SUBJECT: POINT BEACH NUCLEAR PLANT, UNITS 1 AND 2 - REVIEW OF LEAK-BEFORE-BREAK EVALUATION FOR THE RESIDUAL HEAT REMOVAL SYSTEM PIPING AS PROVIDED BY 10 CFR PART 50, APPENDIX A, GDC 4 (TAC NOS. MA7836 AND MA7837)

SAFETY EVALUATION OF THE REQUEST TO APPLY FOR
LEAK-BEFORE-BREAK STATUS TO PORTIONS OF THE
RESIDUAL HEAT REMOVAL SYSTEM PIPING AT THE
POINT BEACH NUCLEAR PLANT, UNITS 1 AND 2

Figure 1 Point Beach Unit 1 RHR Line Layout

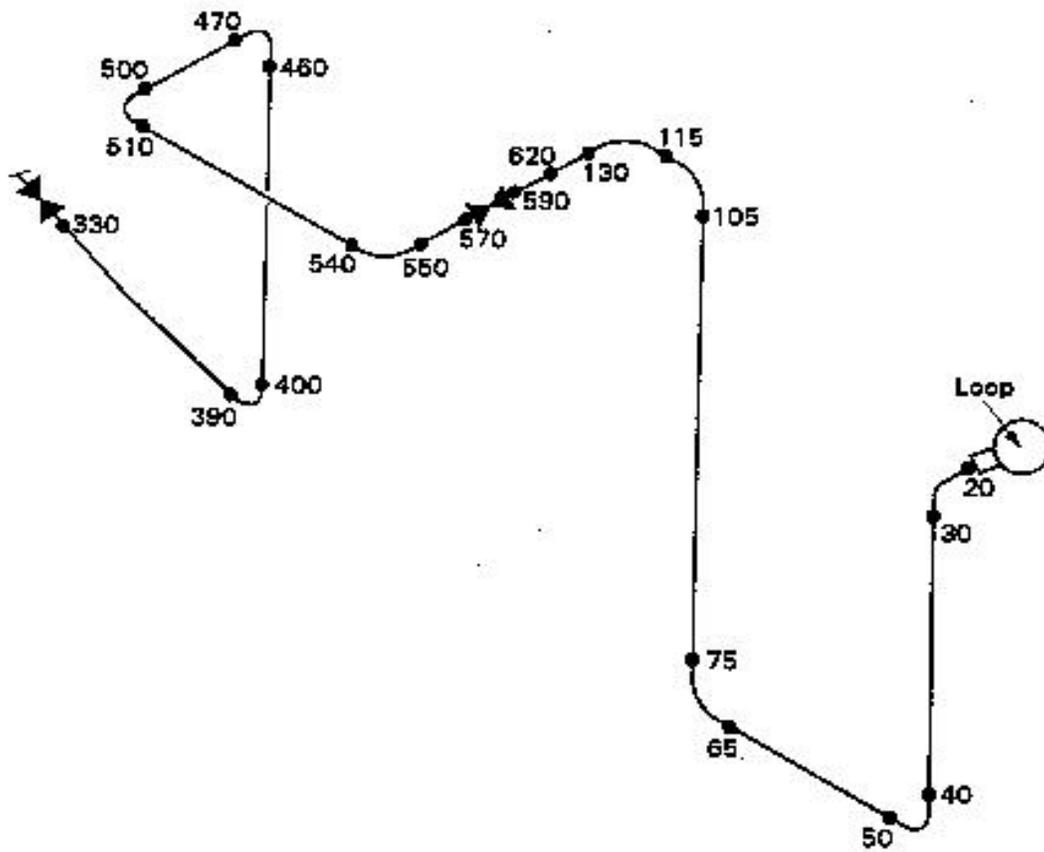
Based on the loadings supplied by the licensee in their August 16, 2000, RAI response and preliminary scoping calculations, the staff concluded that the locations which would be expected to be limiting for the RHR piping evaluation would be node 40 in either the Unit 1 or Unit 2 RHR system. The analysis for the SS weld at Unit 2, node 40 was subsequently determined to bound all of the analyzed RHR piping locations. Since the weld at node 40 existed between two sections of wrought 316 SS piping, the LBB.ENG3 code was used to evaluate the impact of the base material stress-strain properties on each side of the weld. Using base material properties, as submitted by the licensee for 598 °F, the aged SS weld properties cited in Table 3, and the J-R curve based on the information from Wilkowski and Ghaliadi, the staff calculated that the critical flaw size at Point Beach, Unit 2, node 40 would be 7.73 inches under NOP plus SSE loading conditions.

The staff then used the PICEP code to evaluate the leakage flow size for node 40. Using the surface roughness value that the staff has used in previous LBB evaluations of $\epsilon = 0.003$ inch, the staff determined that 10 gpm of leakage would be expected from a 4.48-inch through-wall flaw. Therefore, the factor of safety between the length of critical and leakage size flaws using this approach would be $(7.73/4.48) = 1.73$. In previous LBB evaluations, the staff has concluded that margins of slightly less than 2 on the critical-to-leakage flaw size are acceptable provided that a full margin of 10 is maintained on the leakage uncertainty. The NRC staff concluded that for this evaluation, a margin of 1.73 provides adequate assurance that the Point Beach, Units 1 and 2, RHR system piping will exhibit LBB behavior. Finally, the 4.48-inch leakage flaw was shown to be stable under a combination of NOP plus SSE loads. Therefore, both LBB criteria were demonstrated for the bounding location.
